# Proposed Tiger Crossings, Haverhill, Suffolk

Stage 1 Road Safety Audit

Reference: PB8301\_HTC\_RSA1\_F01

Extracts from drawing PB8301-RHD-DE-HI-DR-D-0150, showing absence of deflection on approach to the Tiger crossing for cyclist

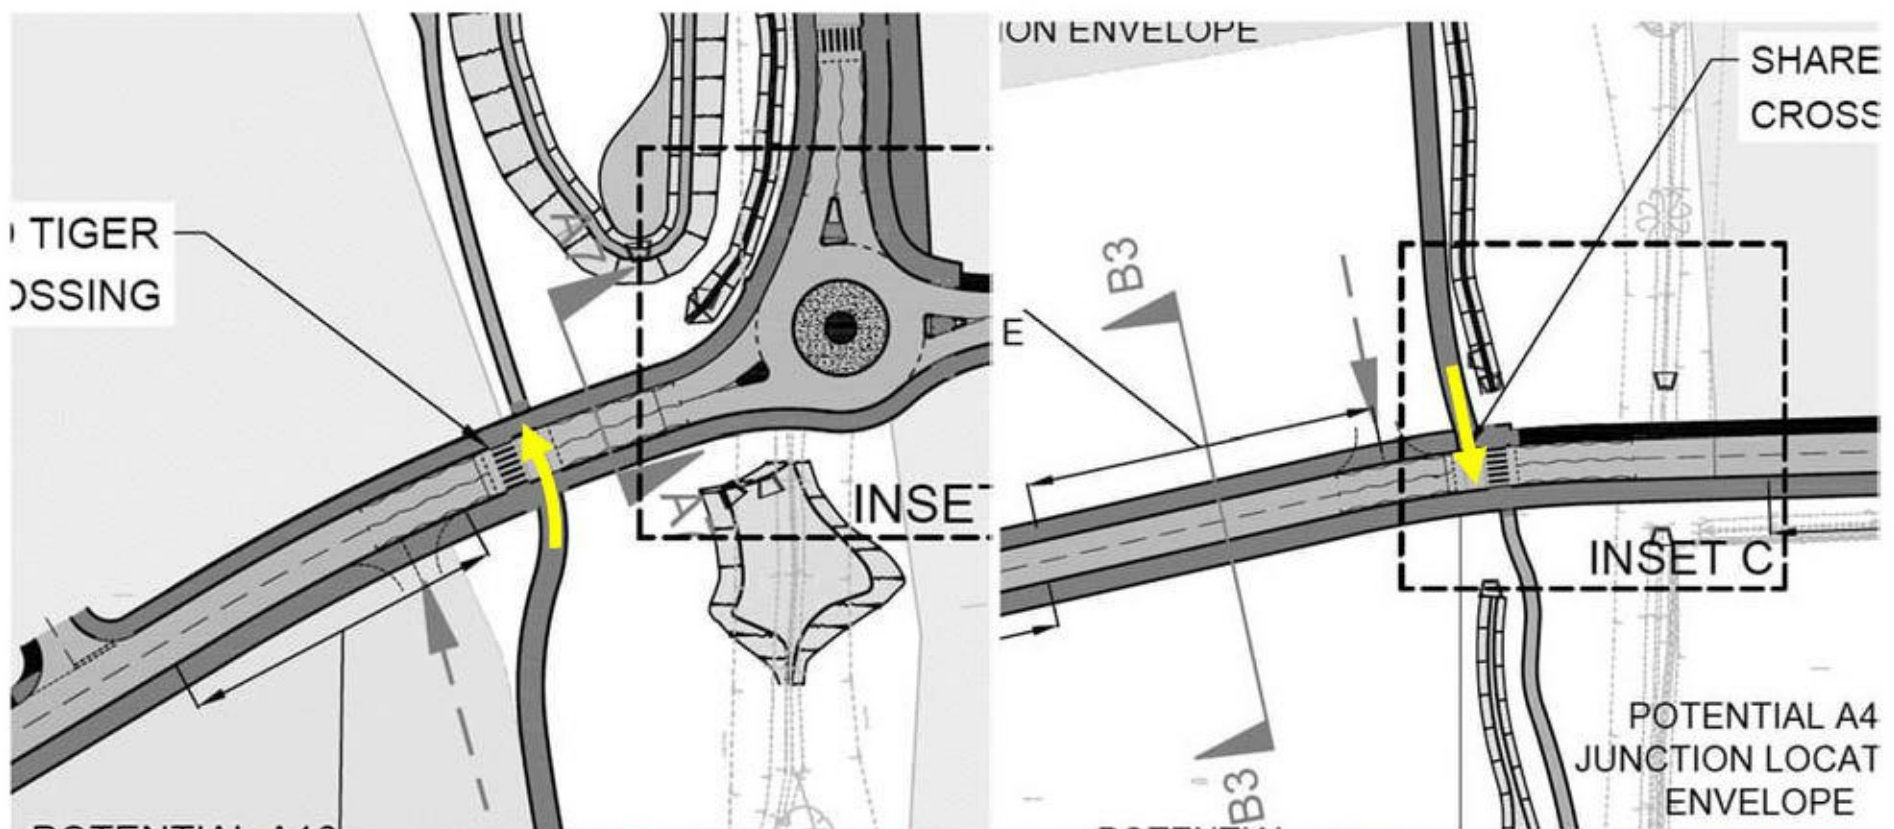
#### A4.1.2 Problem 3

**Location:** Footway/ cycleway approach to proposed Tiger crossing (shown at western extent of Inset A, on Inset C and at the south-eastern extent of drawing PB8301-RHD-DE-HI-DR-D-0150).

**Summary:** Absence of deflection on approach to the cycle crossing element of the proposed Tiger crossing could result in inappropriate cycle speeds, leading to collisions between road users or sudden braking and rear end shunts on the main road.

**Description:** No deflection or deviation of the footway/ cycleway approach to the Tiger crossing has been provided. The cycle element of the Tiger crossing is directly in line with the footway/ cycleway, which allows cyclists to approach and enter the crossing at speeds. Drivers on the main road may brake sharply upon seeing a cyclists approaching the crossing at speed, resulting in rear end shunts.

Furthermore, cyclists approaching the crossing at speed may be unable to slow/ stop sufficiently before entering the carriageway, resulting in collisions with road users on the main road.

#### RECOMMENDATION

Provide deflection on approach to the Tiger crossings to slow cyclists as they approach the facilities. If it is not possible to provide adequate deflection, measures such as bollards or 'SLOW' markings should be installed. The installation of any bollards should consider the footway width requirements of wheelchair users and those pedestrian with additional mobility requirements, such as those with pushchairs/ walking frames.

In conjunction with the above, sufficient forward visibility should be provided on the deflected approaches to the Tiger crossings from the footway/ cycleways, increasing intervisibility between all road users.

TITLE	PROJECT
PROBLEM LOCATION PLAN	PROPOSED TIGER CROSSINGS, HAVERHILL STAGE 1 ROAD SAFETY AUDIT

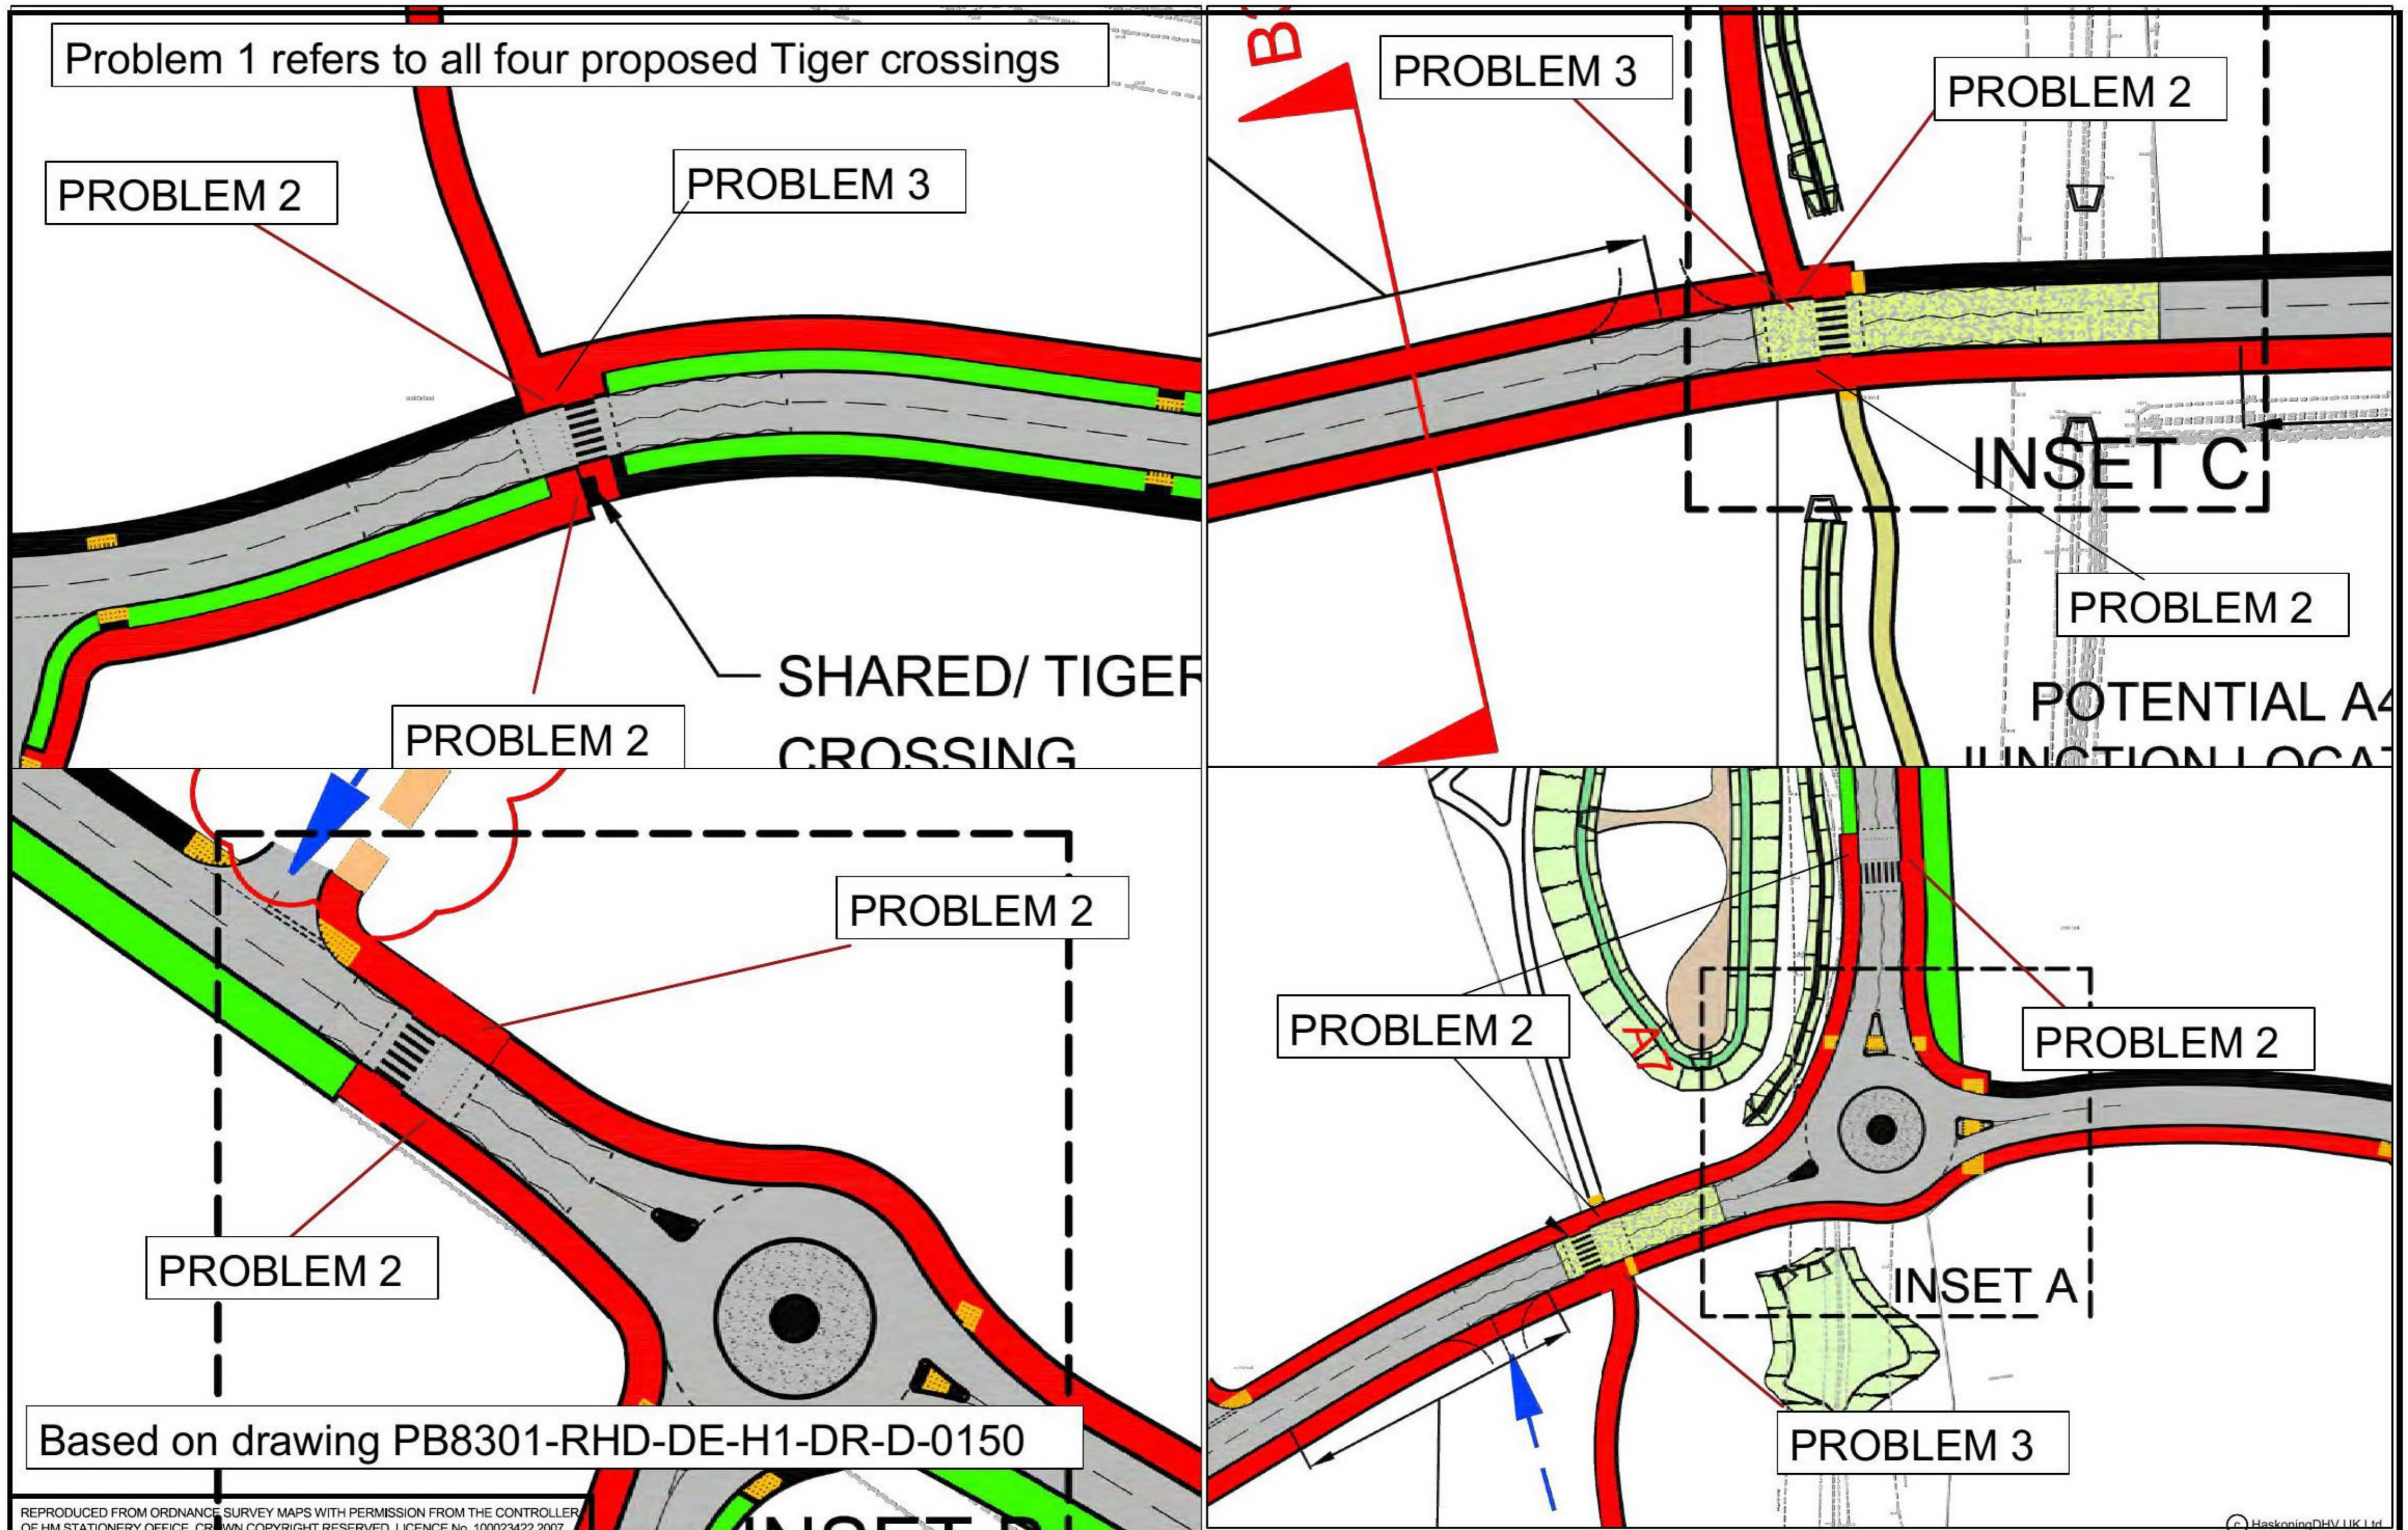
##### A2.1.1 Problem 1

Location: Proposed Tiger crossings.

Summary: Inappropriate vehicle speeds on approach to the Tiger crossings could result in sudden braking and rear end shunts or to crossing overshoot, leading to collisions with pedestrians/ cyclists.

Description: The proposed Tiger crossings adjacent to Inset C on Drawing PB8301-RHD-DE-HI-DR-D-0150 and to the south-east of the scheme are located on relatively long, straight sections of highway, which could result in high vehicle approach speeds. Inappropriate vehicle approach speeds could result in sudden braking and rear end shunts or to collisions with pedestrians/ cyclists on the crossing.

Whilst the remaining three crossings are situated adjacent to roundabouts, one the inbound approaches are also after relatively long straight sections.

#### **A4.1.1 Problem 2**

Location: Footway/ cycleway approaches to all proposed Tiger crossings.

Summary: Inappropriate transition between the footway/ cycleway and the proposed Tiger crossings could result in pedestrian trips/ falls or cycle loss of control collisions or injuries due to a fall.

Description: Details of the type of transition between the proposed Tiger crossing and the footway/ cycleway have not been provided to the Audit Team at this stage. Inappropriate transition between the footway/ cycleway and the proposed Tiger crossings could result in pedestrian trips/ falls, particularly for those pedestrians with additional mobility requirements such as wheelchair users, the elderly or those with pushchairs/ buggies. An inappropriate transition could also result in the destabilisation of cyclists, leading to loss of control collisions or injuries due to a fall.

#### RECOMMENDATION

The Audit Team acknowledge that accesses associated with future development could increase activity on the proposed highway approaches to the Tiger crossings, potentially leading to reduced vehicle speeds. However, during off-peak traffic periods vehicle speeds could be inappropriate and, as such it is recommended that the Tiger crossings are situated on raised tables, or humped, slowing traffic on the approach and reducing the potential for sudden braking or collisions with pedestrians/ cyclists on the crossings.

### **RECOMMENDATION**

Transitions with an upstand of between zero millimetres (mm) and 6mm should be provided at the kerb face approach to the Tiger crossings. A flush transition, or one with a small upstand, would reduce the potential for pedestrian trips and falls, cycle loss of control collisions or injuries sustained as a result of a fall from a bicycle.
